Trio Architecture pllc
17 Wilson Pl
Hastings on Hudson NY

For: Sharon and Chris Callahan
23 Matthiessen Park
Irvington, NY
Tax Map 2.50-17-17

To: Village of Irvington Architectural Review Board

We are submitting a revision to a previously approved exterior elevation change.

A-300
REV

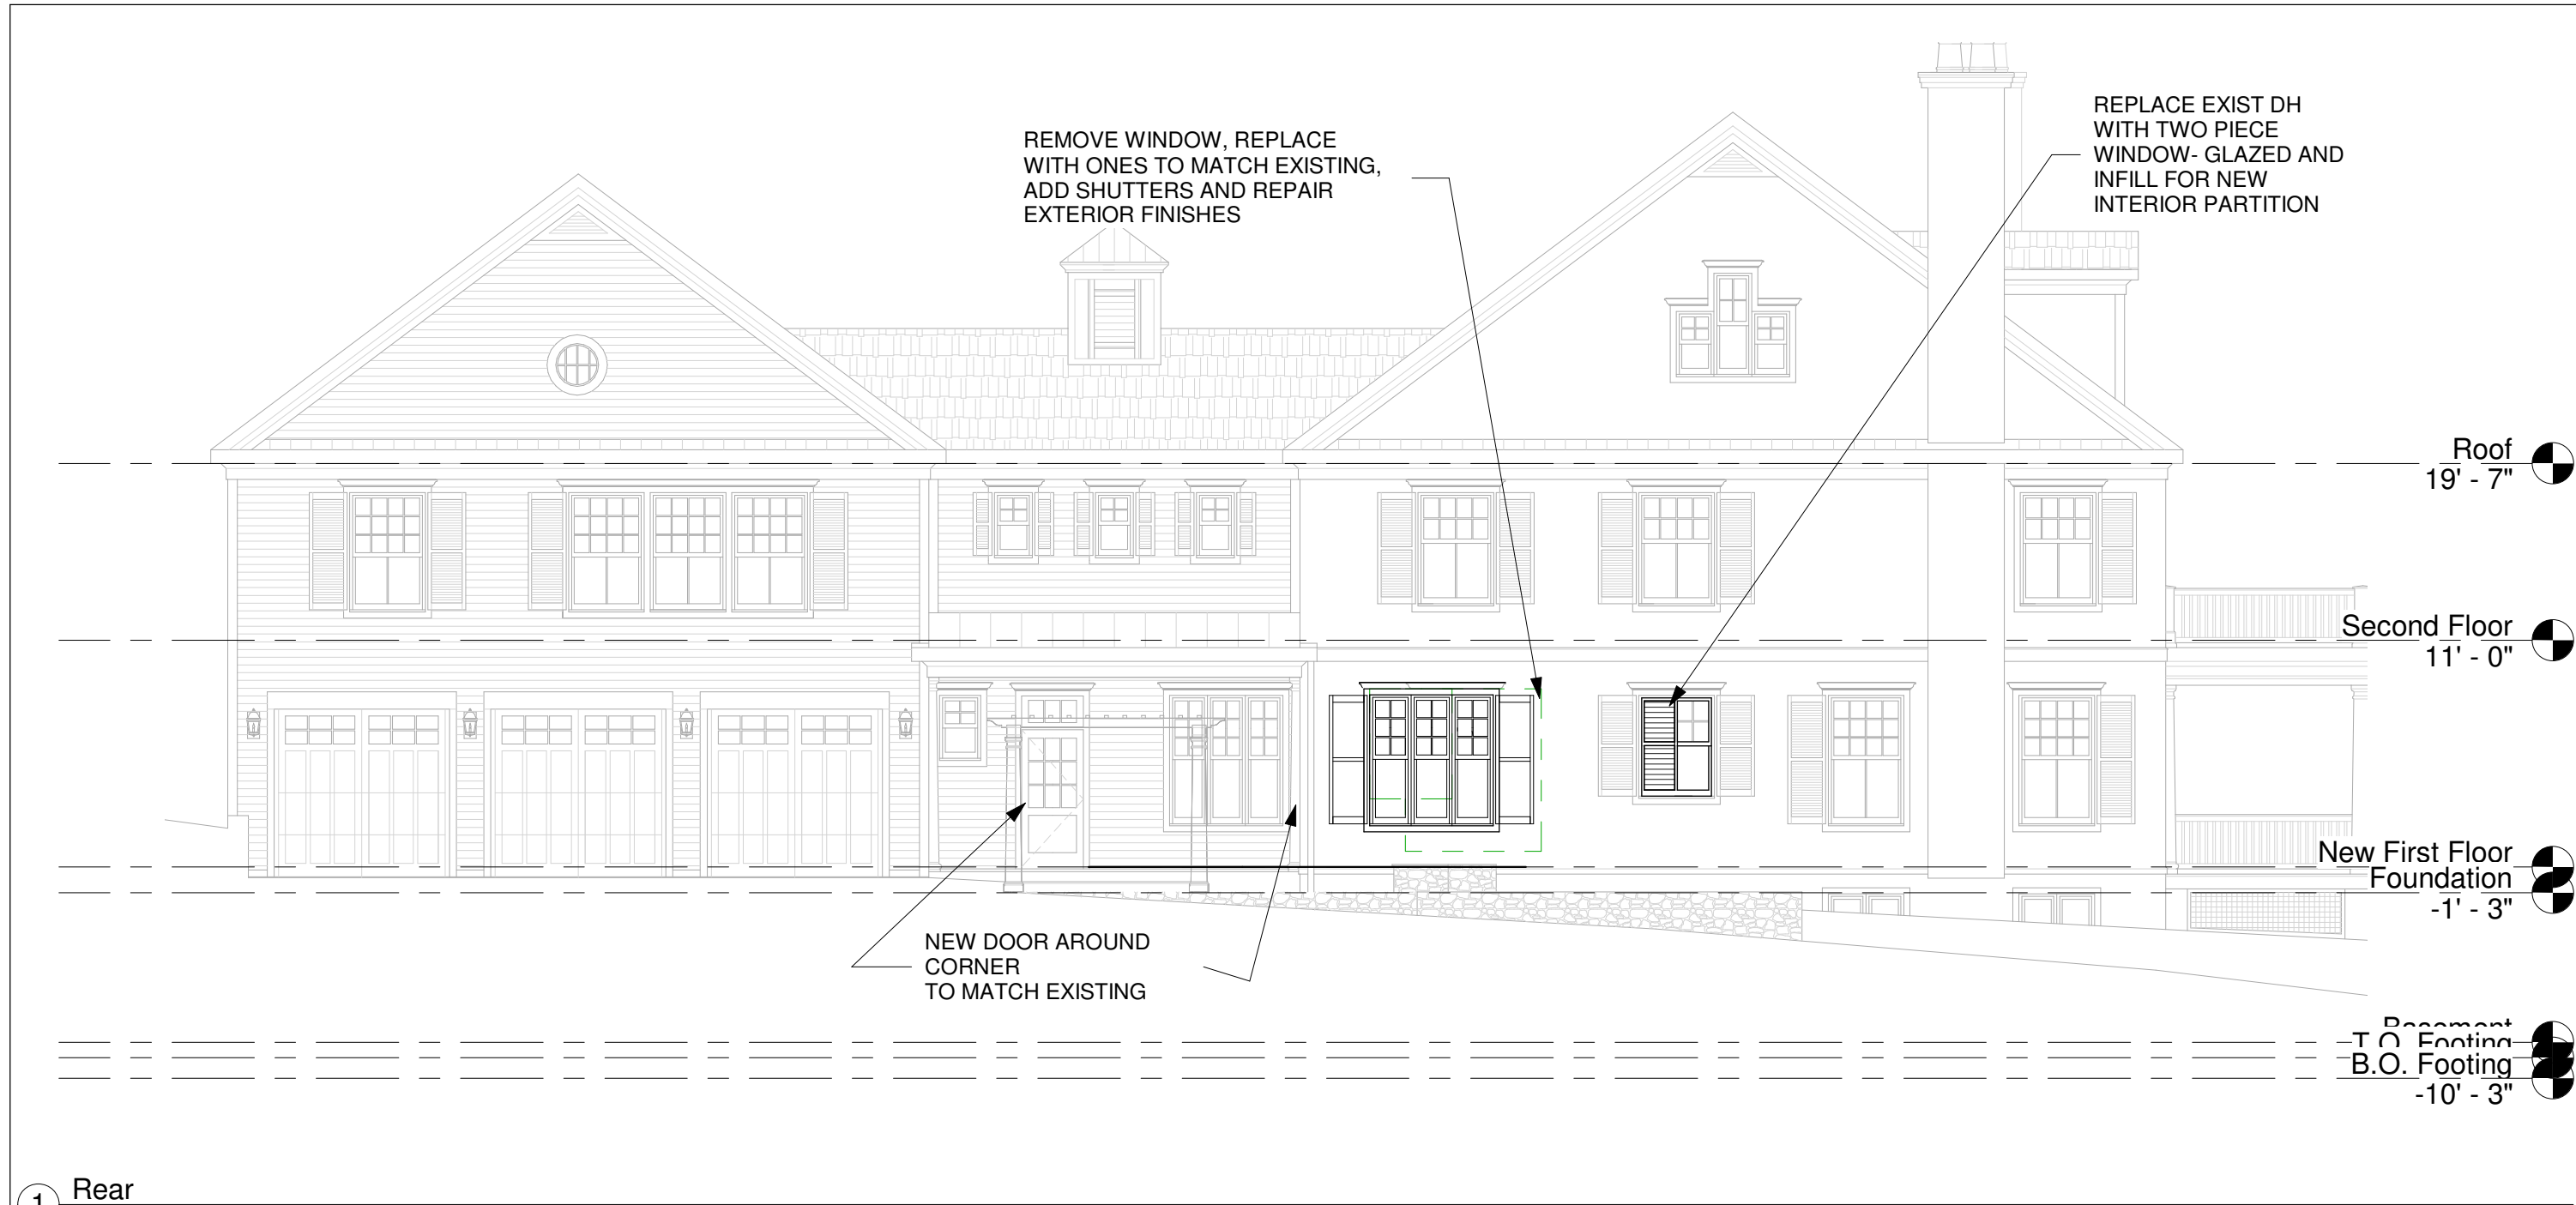
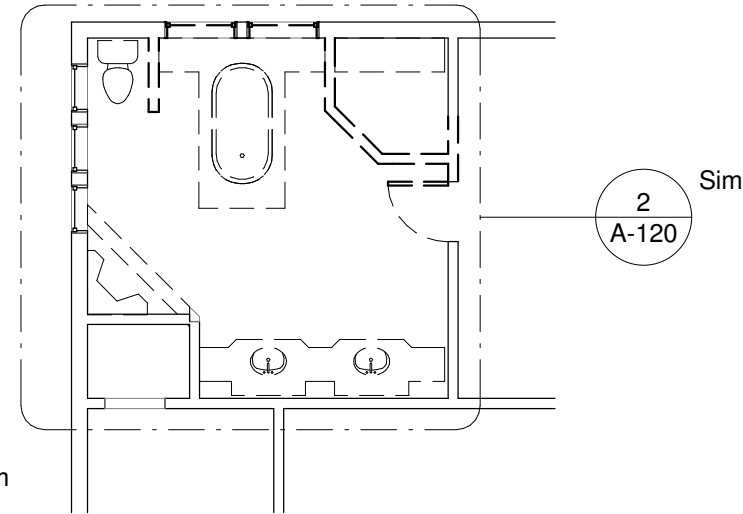
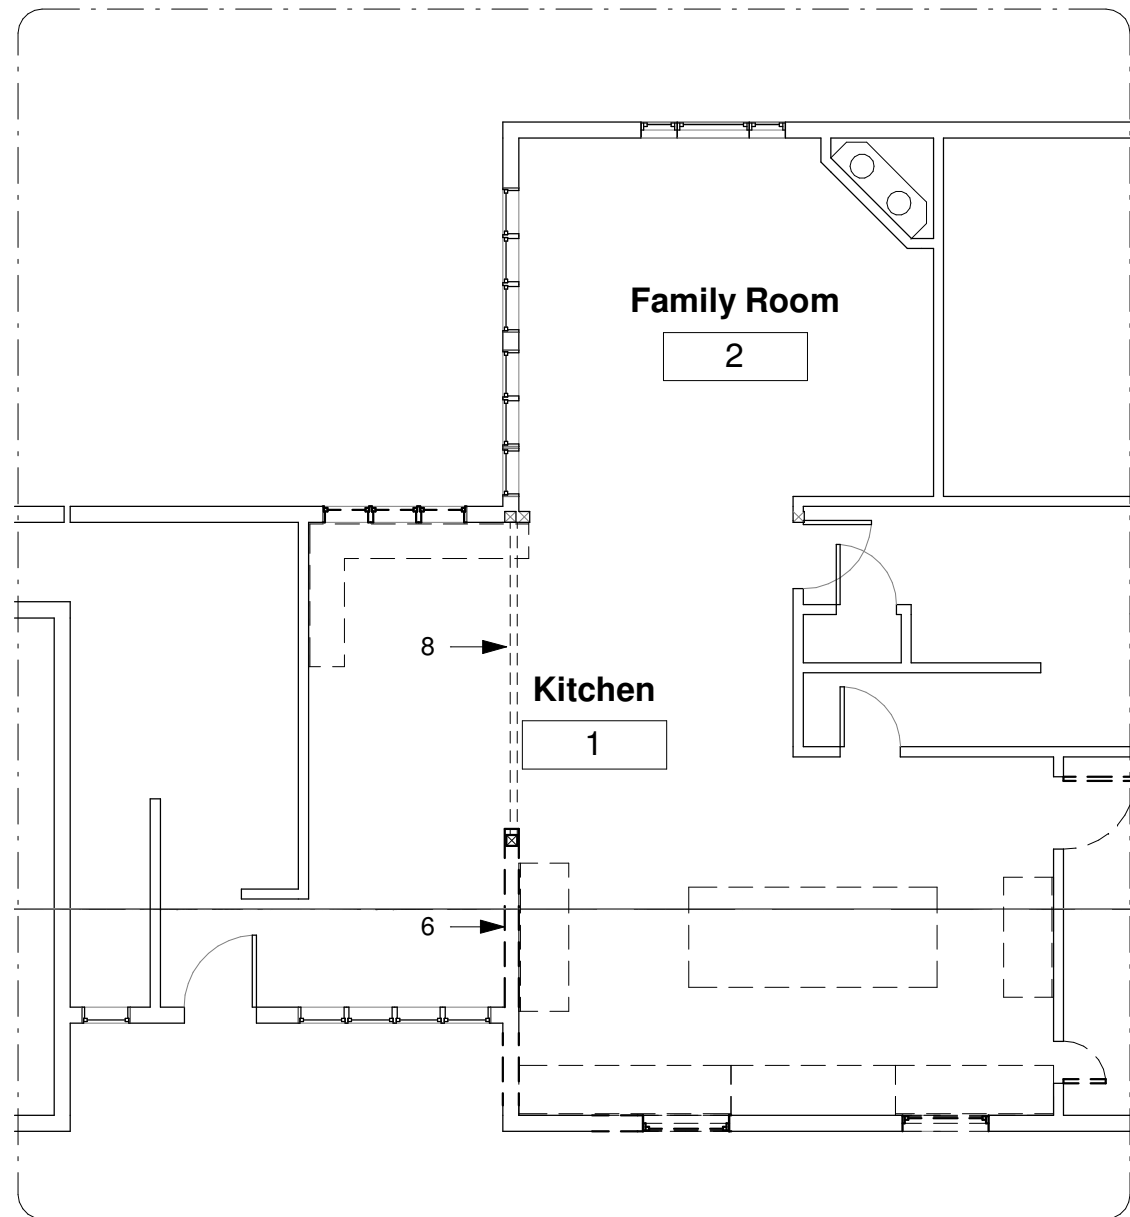
As the project developed, the client chose a different location for the exterior doors and windows

NO.	DESCRIPTION
1	REMOVE WINDOWS AND REPAIR EXTERIOR FINISHES-WINDOW REMOVAL APPROVED BY ARB
2	REMOVE WINODWS INSTALL NEW DOUBLE DOOR WITH SIDELIGHTS AND TRANSOM TO MATCH ADJACENT
3	SALVAGE EXIST DH- INSTALL SALVAGED WINDOWG, ADD SHUTTERS AND REPAIR EXTERIOR FINISHES
4	SALVAGE EXIST DH- MATCH EXIST EXT FINISH
